Appendix M2

Stage 1 Road Safety Audit

BusConnects Core Bus Corridors
- Blanchardstown to City Quays

Document Ref: P20-138-PSW1-RP-001

3.1.1 Problem

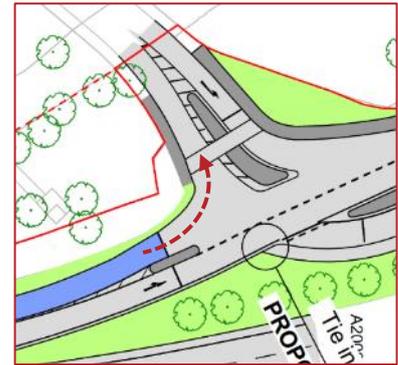
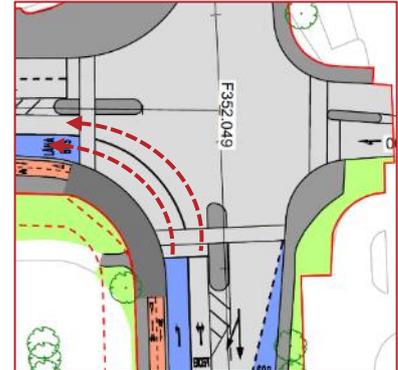
Location: At a number of junctions throughout the Scheme⁵⁶

Example: Drawing no. BCIDC-ARP-GEO_GA-0005_XX_00-DR-CR-0004 (Rev. L01);
Drawing no. BCIDC-ARP-GEO_GA-0005_XX_00-DR-CR-0005 (Rev. L01)
Drawing no. BCIDC-ARP-GEO_GA-0005_XX_00-DR-CR-0014 (Rev. L01);
Drawing no. BCIDC-ARP-GEO_GA-0005_XX_00-DR-CR-0027 (Rev. L01)

Summary: It is unclear if there will be sufficient space within signalised junctions to accommodate the swept path of all vehicles, especially HGVs and buses, particularly where adjacent turning lanes receive a green signal during the same phase.

Information regarding the swept path of vehicles undertaking turning movements at proposed signalised junctions within the Scheme have not been provided to the Audit Team. The Audit Team are concerned that there will not be sufficient space at all junctions to accommodate the swept path of all vehicles, particularly HGVs and buses, within the proposed junction layouts. This is a particular concern where adjacent turning lanes proceed simultaneously on one phase as drivers may encroach within the path of an adjacent vehicles resulting in low-speed collisions.

Additionally, during the site visit, the Audit Team noted buses and large vehicles encroaching into adjacent traffic lanes at existing junctions when entering/exiting side roads, for example at the entrance to Connolly Hospital where a bus was observed straddling two lanes of traffic when entering Connolly Hospital. At this particular location it is proposed to provide physical islands which may lead to further difficulties for turning buses.

A comprehensive swept path analysis should be undertaken to demonstrate that all new, and revised, signalised junctions can sufficiently accommodate the swept path of all vehicles. Where constraints are identified, the layout should be revised to ensure all vehicle movements can be accommodated.

3.1.3 Problem

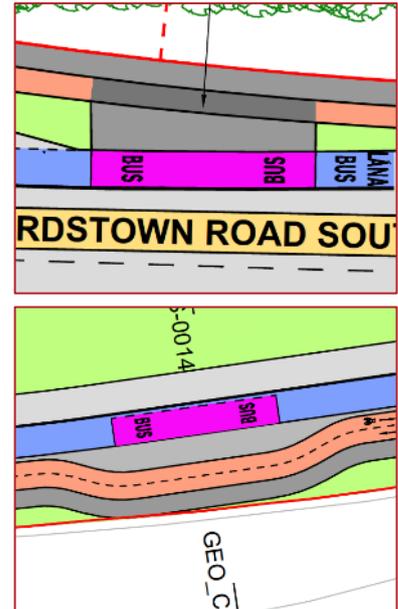
Summary: Potential for cyclist/pedestrian collisions where bus passengers are required to cross the cycle track when boarding or alighting buses at bus stops throughout the Scheme.

At some locations a footpath link is indicated between a bus stop island and the adjacent footpath, with pedestrians & cyclists occupying the same space for a short distance.

At other locations no footpath link has been indicated at these “floating” or “island” type bus stops and the cycle track is shown as being continuous through the bus stop location.

At this early stage in the design process no tactile paving (either warning or guidance) has been indicated. Should insufficient guidance be provided where a shared surface is indicated between the bus stop and the adjacent footpath, this could result in an increased risk of collisions between cyclists and pedestrians where cyclists may be insufficiently aware of the shared area and of the need to moderate their speed or even come to a halt.

An absence of Guidance Tactile Paving could result in increased difficulties for the visually impaired who may be unaware of how to access or leave the bus stop island.

Where no connection has been indicated between the footpath and the bus stop island, this will result in mobility impaired & visually impaired road users being unable to access the public transport provisions, and there would be an increased potential for cyclist/pedestrian collisions as embarking/disembarking passengers traverse the cycle track.

A link should be provided between the proposed island/floating bus stops and the adjacent footpath, with the cycle track crossing the footpath link. Guidance Tactile Paving should be provided to guide visually impaired pedestrians to/from the footpath & the bus stop island.

Measures should be provided on the cycle track approaches to these footpath links, for example Ladder & Tramline tactile paving & Yield road markings, so that cyclists are aware that they are approaching a footpath crossing and that they should slow down & give way to pedestrians at these locations.

3.1.6 Problem

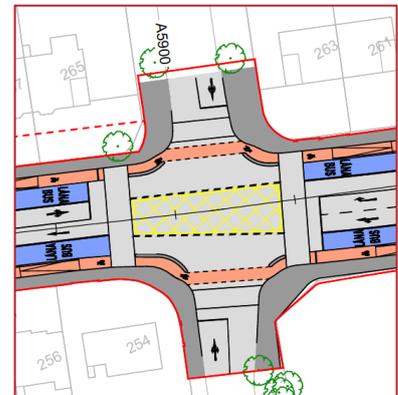
*Example: Drawing no. BCIDC-ARP-GEO_GA-0005_XX_00-DR-CR-0023 (Rev. L01)
Drawing no. BCIDC-ARP-GEO_GA-0005_XX_00-DR-CR-0025 (Rev. L01)
Drawing no. BCIDC-ARP-GEO_GA-0005_XX_00-DR-CR-0026 (Rev. L01)
Drawing no. BCIDC-ARP-GEO_GA-0005_XX_00-DR-CR-0030 (Rev. L01)*

Summary: Unclear how cyclists are intended to turn right at some protected intersections.

3.1.9 Problem

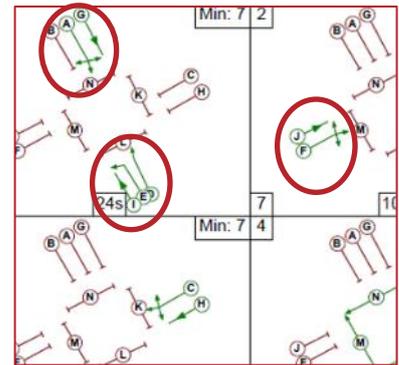
Example: Queen Street/Blackhall Street Junction;
Manor Street/Kirwan Street Junction;
Prussia Street/North Circular Road Junction;
Navan Road/Phoenix Park Road Junction

Summary: Left turning manoeuvres are indicated during the same signal phase as straight-ahead cyclists where turning drivers may be insufficiently aware of cyclist proceeding straight at a number of the protected intersections/junctions within the Scheme.

At a number of signalised protected junctions within the Scheme left turning manoeuvres are indicated as occurring during the same phase as straight-ahead cyclists. In some instances the, straight through cycle lane is offset from the adjacent traffic lane, and is positioned closer to the pedestrian crossing on the intersected road.

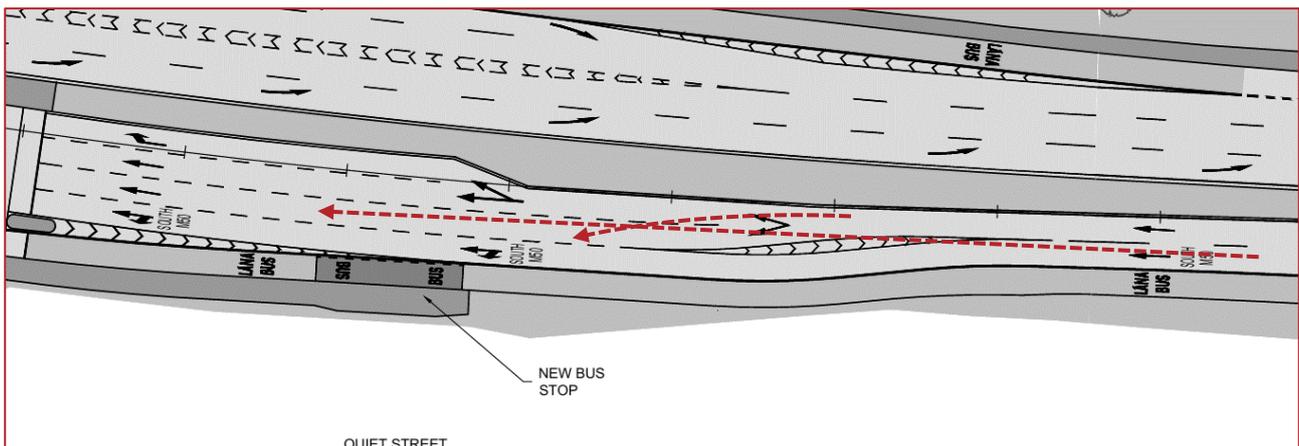
Location: Drawing no. BCIDC-ARP-GEO_GA-0005_XX_00-DR-CR-0014 (Rev. L01)

Summary: Lane configuration may result in side-swipe collision.

The proposed road layout on the N3 westbound carriageway approaching the intersection with Auburn Avenue & Dunsink Lane requires vehicles in the nearside traffic lane to move left, while the offside lane splits into two straight-ahead lanes and one right-turn lane.

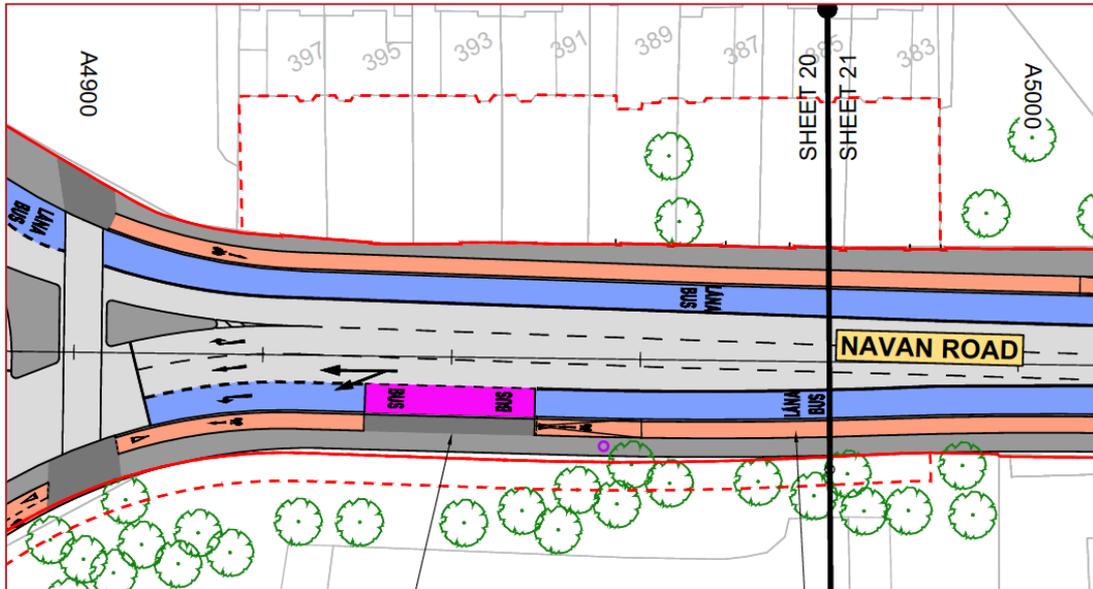
Location: Drawing no. BCIDC-ARP-GEO_GA-0005_XX_00-DR-CR-0020 (Rev. L01)

4. It is necessary that a number of traffic signals will be required at the junction and the layout of the junction, combined with its size, may result in drivers sighting onto signals intended for other drivers. As a result, the proposed layout may not be easily discernible to drivers increasing the risk of collisions.

The proposed layout at this junction should be reviewed further and an arrangement proposed that will maintain traffic flow through the roundabout such that excessive queues do not develop. The layout of the roundabout should be easily understood by drivers.

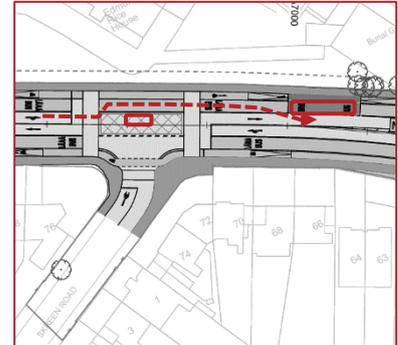
Location: Drawing no. BCIDC-ARP-GEO_GA-0005_XX_00-DR-CR-0020/21 (Rev. L01)

The westbound straight-ahead lane on the Navan Road continues to form the right turn lane upstream of the proposed signalised roundabout junction at the Halfway House bar/restaurant. Westbound drivers may be insufficiently aware of the lane becoming a right-turn-only lane on the approach as only a single right turn arrow is indicated immediately upstream of the stop lane. This could lead to westbound drivers becoming aware of the change in road layout immediately upstream of the roundabout resulting in late lane-change manoeuvres and possible side-swipe collisions.

Amend the commencement of the additional traffic lane on the Navan Road so that traffic continues in the straight-ahead lane, with a bifurcation arrow provided downstream advising drivers of the development of the offside lane should they wish to turn right at the junction.

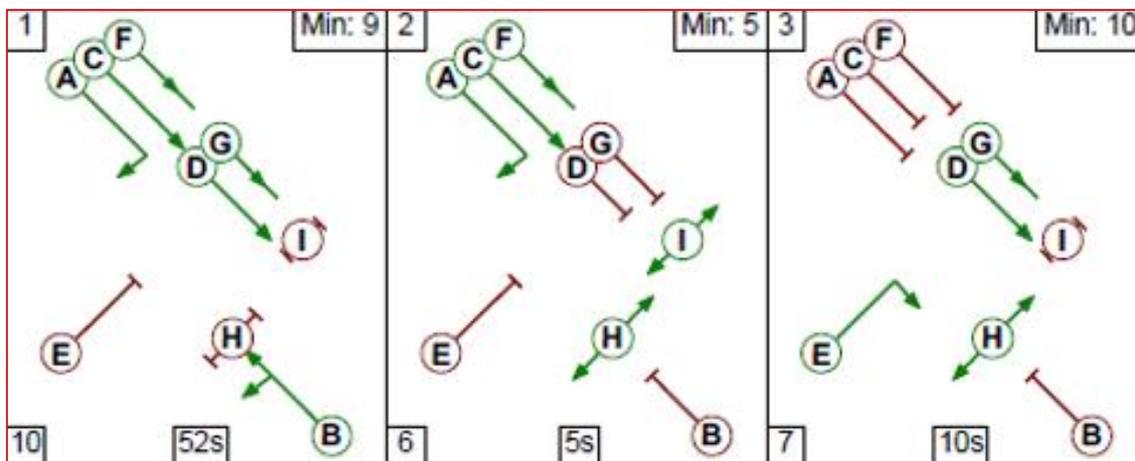
Parallel parking spaces have been indicated on Manor Street and Blackhall Place. The width of these parking spaces is however unclear from the drawing provided and the Audit Team are concerned that they may not be sufficiently wide to accommodate vehicles without them encroaching into the adjacent traffic lane, as they appear narrow relative to the traffic lanes. Should the vehicles encroach into the traffic lane there is a risk that drivers may cross the centreline/edge of traffic lane and enter the opposing traffic lane to avoid a stationary vehicle resulting in an increased risk of head-on, or material damage, collisions.

Ensure the parallel parking spaces are sufficiently wide enough to accommodate a stationary vehicle.

3.2.1 Problem

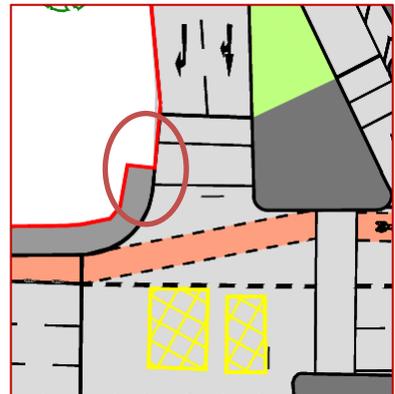
Drawing: BCIDC-SRP-GEO_GA-0005_XX_00-DR-DR-0001 (Rev. L03)

Ensure the island can accommodate the expected pedestrian volumes using the crossing and that it is sufficiently wide to accommodate wheelchair users and pedestrians with strollers.

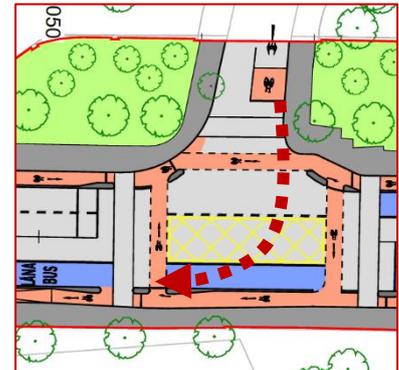
Drawing: BCIDC-SRP-GEO_GA-0005_XX_00-DR-DR-0021 (Rev. L03)

It is proposed to remove the Ashtown Roundabout and provide a signalised junction in its place. However, the widths of the proposed pedestrian crossings at the signalised junction appear to be quite narrow relative to other crossings within the Scheme. This may lead to these crossings failing to sufficiently accommodate the volume of pedestrians and cyclists at this location resulting in potential conflicts.

Ensure the pedestrian crossings are sufficiently wide enough to accommodate the expected volume of pedestrians, noting that DMURS recommends at least 4m wide crossing widths in urban areas.

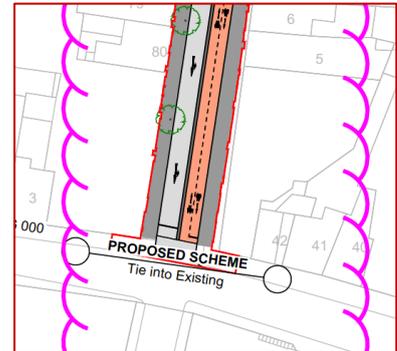
Drawing: BCIDC-SRP-GEO_GA-0005_XX_00-DR-DR-0035 (Rev. L03)

It is proposed to provide two-way cycle lanes along the eastern side of Queen Street, with kerbs indicated to segregate the cycle lanes from the adjacent traffic lane. An existing car park structure is accessed via Queen Street at this location. A gap has been indicated in the kerb however it does not extend across the full width of the access. This may lead to cars having to mount the kerb when entering/exiting the carpark increasing the risk of material damage collisions or to drivers attempting to enter/exit via the narrow gap indicated increasing the risk of low speed head-on collisions.

The gap in the kerb should be extended across the full width of the carpark access.

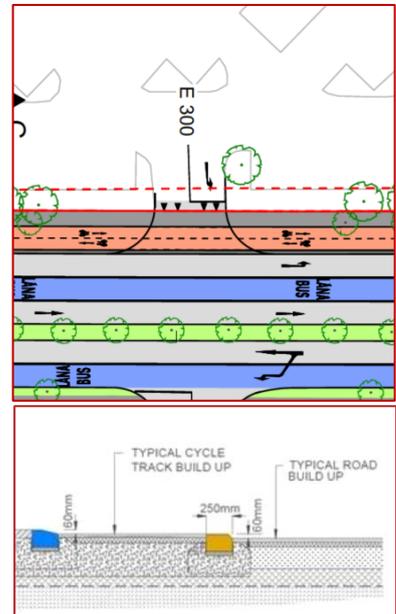
Drawing: BCIDC-SRP-GEO_GA-0005_XX_00-DR-DR-0002 (Rev. L03)

Ensure that the swept path of large vehicles can be accommodated when turning right at this junction.
